Access Compliance Report

Public Rights-of-Way

(Curb Ramps)

Intersection ID: 11480	Main Street: N_CEDAR_ST	Cross Street: W_5TH_ST	Location: N
ADA ID: 42C71F3E57E4	Ramp Type: Para	Initial Pass/Fail: Fail	Overall Compliance: No
			Severity Score: 26.25

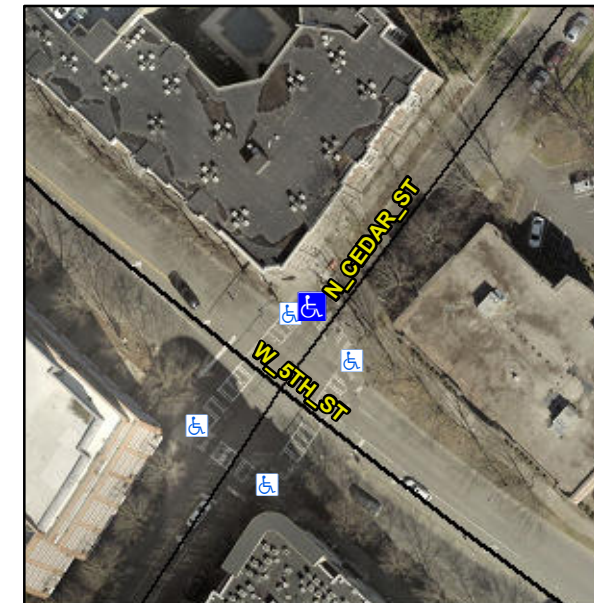
R304.3.2, R304.5.3

Compliance	Description	Data	Compliance	Description	Data
N/A	Ramp Length LT (in)	64.0	N/A	Ramp Length RT (in)	70.0
Yes	Ramp Width LT (in)	74.0	Yes	Ramp Width RT (in)	74.0
No	Ramp Slope LT (%)	14.8	Yes	Ramp Slope RT (%)	5.5
No	Ramp XSlope LT (%)	2.6	No	Ramp XSlope RT (%)	2.5
N/A	Landing Length (in)	N/A	N/A	DWS Provided?	N/A
N/A	Landing Width (in)	N/A	N/A	DWS Contrast?	N/A
N/A	Landing Slope (%)	N/A	N/A	DWS Length (in)	N/A
N/A	Landing X Slope (%)	N/A	N/A	DWS Full Width?	N/A
N/A	Landing Curb? (Y/N)	N/A	N/A	DWS Offset (in)	N/A
N/A	Shared Landing?	N/A			
N/A	Gutter Ponding?	N/A	N/A	Gutter Slope (%)	N/A
N/A	Gutter Lip Ht (in)	N/A	N/A	Gutter X Slope (%)	N/A
N/A	Painted X Walk1?	Yes	N/A	Painted X Walk2?	N/A
	X Walk 1 Direction	To SE		X Walk 2 Direction	N/A
N/A	X Walk 1 Width (in)	121.0	N/A	X Walk 2 Width (in)	N/A
	X Walk 1 Slope (%)	8.3		X Walk 2 Slope (%)	N/A
	X Walk 1 X Slope (%)	6.1		X Walk 2 X Slope (%)	N/A
N/A	Ramp inside XWalk1?	Yes	N/A	Ramp inside XWalk2?	N/A

Remove & Replace Entire Ramp.
